South Texas Project Electric Generating Station P.O. Box 289 Wadsworth, Texas 77483

May 27, 2010
U7-C-STP-NRC-100088

South Texas Project
Units 3 and 4
Docket Nos. 52-012 and 52-013
Response to Request for Additional Information

Attached are responses to NRC staff questions included in Request for Additional Information (RAI) letter number 339 related to Combined License Application (COLA) Part 2, Tier 2 Section 6.2 and RAI letter number 344 related to COLA Part 2 Tier 2 Section 9.5.

Attachment 6.2.1.1.C-17-1*

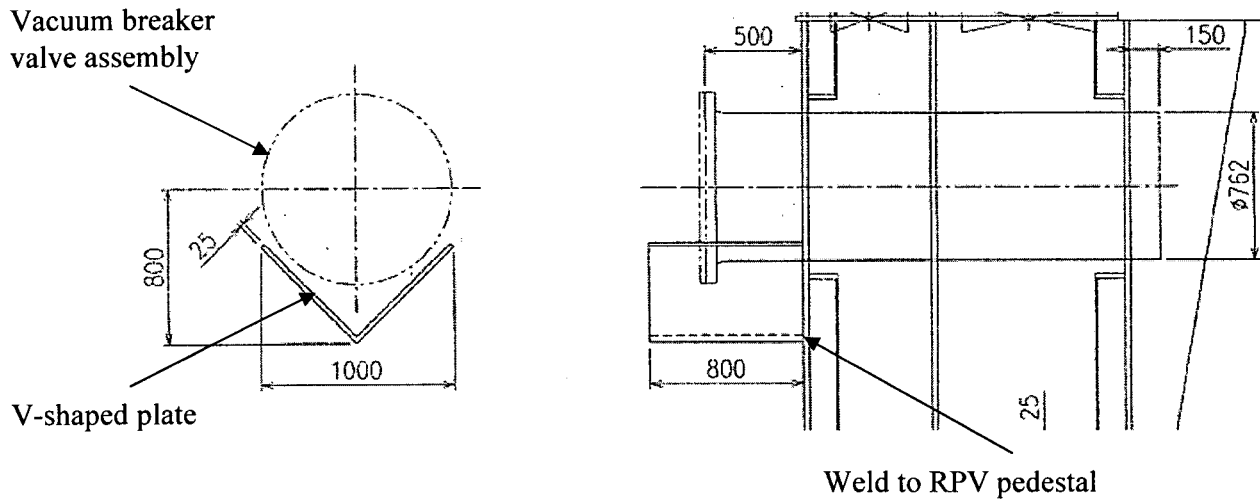
In COL License Information Item 6.5, the applicant has proposed that a vacuum breaker shield (consisting of a solid "V" shaped plate) will be provided below each vacuum breaker to protect the valves against loads due to pool swell under LOCA conditions. However, the actual design of the shield has not provided in the COL FSAR (Rev. 3). Provide detailed design of the vacuum breaker shield discussing/showing it's protective design characteristics.

As noted in STP 3 & 4 COLA Part 2, Tier 2 Subsection 6.2.7.4, a vacuum breaker shield, consisting of a solid "V" shaped plate, is provided below each wetwell to drywell vacuum breaker to protect the valve from LOCA-generated pool swell loads. A sketch of the vacuum breaker design is provided in Attachment 6.2.1.1.C-17-1 to this response. All dimensions on this sketch are preliminary and subject to change based on the results of the pool swell loads analysis.

The "V" shaped plate is a Seismic Category I structure that is attached to and a part of the Reactor Pressure Vessel (RPV) Pedestal outer wall plate. The V-shaped plate is not in contact with the vacuum breakers. The plate will be made of coated carbon steel.

The "V" shape of the plate acts to divert water from the pool swell away from the vacuum breaker valve to avoid pool swell water impingement on the vacuum breaker. The "V" shape of the plate will minimize the pool swell loads on the plate as opposed to a flat plate design.

As noted above, the final dimensions of this protective plate have yet to be determined. The dimensions will be finalized after completion of the pool swell loads structural evaluation later this summer.

* All dimensions on this Figure (shown in mm) are PRELIMINARY and will be finalized after completion of loads analysis.
